Access for People with Disabilities

Design Compliance Report – DA Level Documentation

Upper Australia & Nocturnal House

Taronga Zoo, Bradleys Head Road, Mosman NSW

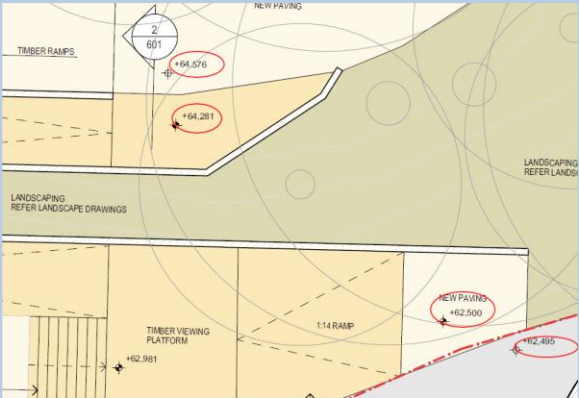
#	Accessibility Requirement	Comment/Recommendation
3.1.1	<p>Access from Boundary</p> <p>An accessway must be provided from the main points of a pedestrian entrance at the allotment boundary to the subject building.</p> <p><i>BCA D3.2(a)(i)</i></p>	<p>Pedestrian entrances at the allotment boundary are generally proposed to be accessible (as shown below in green)</p>

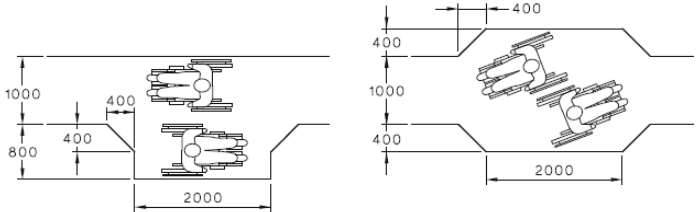
3.2.4	<p>Other Exemptions for Access</p> <p>The following areas are exempt from needing to be accessible:</p> <ul style="list-style-type: none"> -an area that would be inappropriate because of its particular use -an area that would pose a health or safety risk for people with a disability -any path of travel providing access only to an area listed above <p>BCA D3.4</p>	<p>It is considered that the back of house areas in the Nocturnal House which primarily contains animal holding, kitchen/laundry facilities (for animals), plantrooms and storage areas may be subject to an exemption (on the assumption that the staff in these areas would typically need to be able bodied for work health and safety reasons)</p> <p>The Zoo will need to confirm this prior to the issue of a CC.</p>

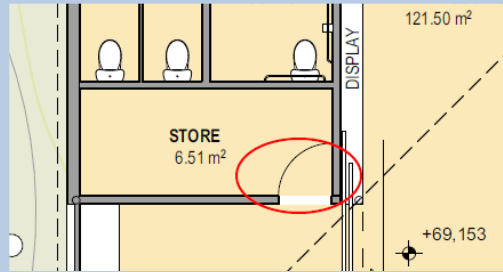
#	Accessibility Requirement	Comment/Recommendation
3.3.1	<p>Accessway Width</p> <p>Accessways should be a minimum unobstructed width of 1000mm (clear of handrails or other obstructions)</p> <p>BCA D3.2 and AS1428.1-2009</p>	The scaled dimensions indicate general compliance.
3.3.2	<p>Accessway Height</p> <p>Accessways must be a minimum of 2000mm in unobstructed height</p> <p>AS1428.1-2009</p>	As above.
3.3.3	<p>Obstructions in Accessways</p> <p>Accessways must not include steps, stairways, turnstiles, revolving doors, escalators, moving walkways or other impediments</p> <p>6.1 of AS1428.1-2009</p>	<p>Accessways appear generally free of steps – however the following spot levels (as shown in red below) are to be confirmed. Differences in levels to comply with AS1428.1.</p>  <p>Note - It is assumed that the line shown in blue below does not represent a step.</p>

#	Accessibility Requirement	Comment/Recommendation
		 <p>The diagram is a site plan showing a timber viewing platform and surrounding infrastructure. Key features include: <ul style="list-style-type: none"> ROPES COURSE POLE at the top. NEW RETAINING WALLS on the left and right. 1:14 RAMP on the right side. TIMBER VIEWING PLATFORM in the center, with a level marker of +63,638. NEW RETAINING WALLS below the platform. 1:14 RAMP at the bottom right. TIMBER RAMPS at the bottom. A blue oval highlights a specific area on the timber viewing platform.</p>

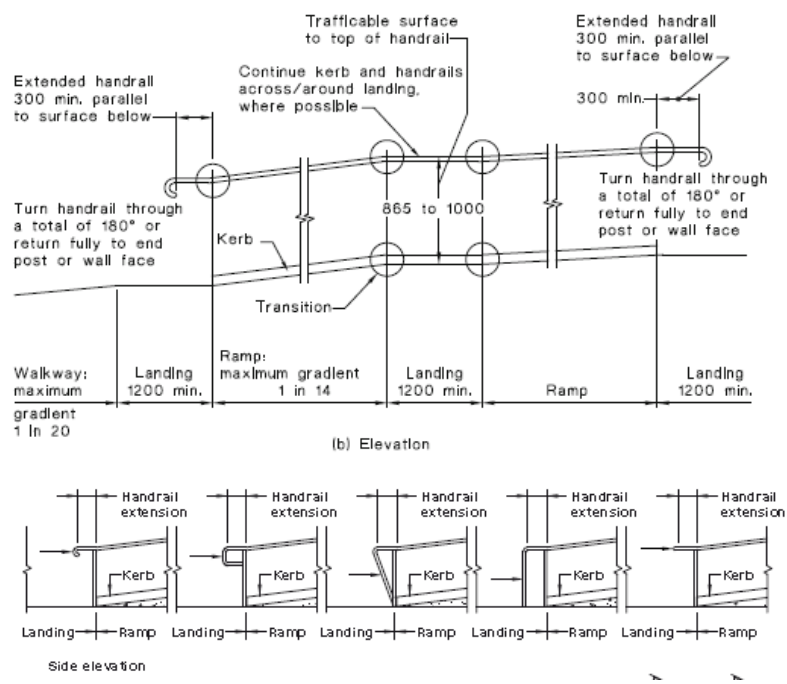
3.7.3	<p>Ramp Landings</p> <p>Ramps must be provided with 1200mm deep landings at appropriate intervals:</p> <ul style="list-style-type: none"> <input type="checkbox"/> Gradients of 1:14, landings at 9m intervals; <input type="checkbox"/> Gradients of 1:19, landings at 15m intervals. <input type="checkbox"/> For ramps with gradients between 1:20 and 1:14 landings shall be obtained by linear interpolation <p><i>Clause 10.3 of AS1428.1-2009</i></p>	<p>Ramp landings appear adequately spaced (dimensions required for ramp landings at CC stage), with the following specific issues noted:</p> <p>A landing will need to be provided between the walkway and ramp as shown below.</p>

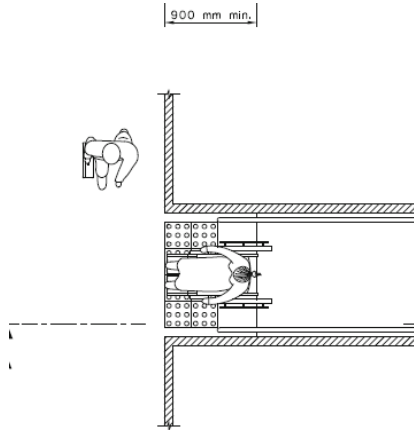
3.7.4	<p>Landing dimensions to ramps</p> <p>Landings must be increased in size where the ramp also changes direction at the landing as follows:</p> <ul style="list-style-type: none"> <input type="checkbox"/> 1500mm x 1500mm for up to 90 degrees (internal corner can be splayed) 	<p>The design appears to provide sufficient turning space at the top and base of the ramps (noting comments above) - dimensions should be confirmed at CC stage.</p> <p>Note that the required handrail extensions (for both the stair and ramp - not currently shown) must not encroach into the required turning space.</p>
